MEMORANDUM

County File No. EP-2020-12924

13801 NW Charlton Rd, Portland, OR 97231

We received your Transportation Planning Review request for your proposal for your land partition at 13801 NW Charlton Rd. Multnomah County Transportation Planning and Development has reviewed the above referenced transportation planning review request and provides the following comments.

Figure 2: Adjacent Public Right-of-Way

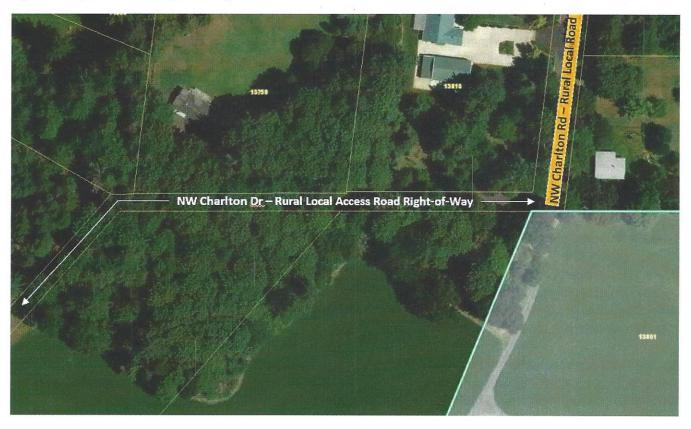
NW Charlton Rd has approximately 45 feet of right-of-way. NW Charlton Dr has approximately 27 feet of right-of-way.

The County standard ROW for a Rural Local road is 60 feet, 30 feet from the road centerline to adjacent property lines (see Figure 5: MCDCM Table 2.2.5 Rural Cross Section). The NW Charlton Dr right-of-way does not meet the standard right-of-way width for Rural Local roads. **This proposal does not result in a transportation impact, therefore no right-of-way dedication is required.** However, the County would likely require right-of-way dedication for any potential future development proposal on the subject site that would result in a transportation impact, as determined by the County Engineer.

Figure 3: Proposed New Parcels

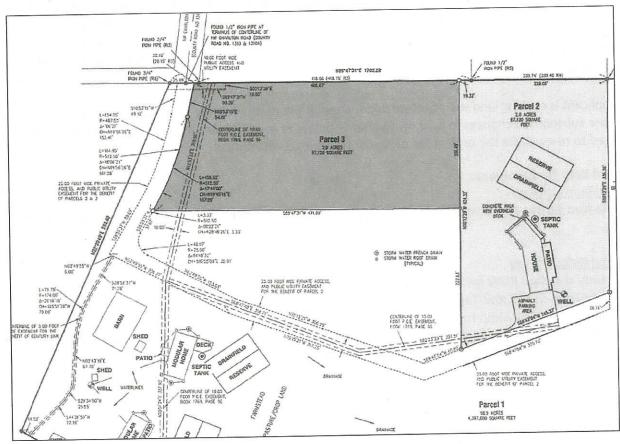
The subject transportation planning review proposal consists of partitioning Tax Lot 900 in Section 16, Township 2 North, Range 1 West. The proposal would result in three lots where there is one existing. The proposal also includes demolishing one of three existing dwellings on the subject tax lot and building a replacement dwelling. The proposal would result in three dwellings, one on each of the proposed tax lots. The applicant is seeking land use approval under Oregon Measure 49. If the land use application is approved and there are subsequent changes in land ownership or delays in construction of the replacement home, the County will need to reevaluate the project for potential transportation impacts.
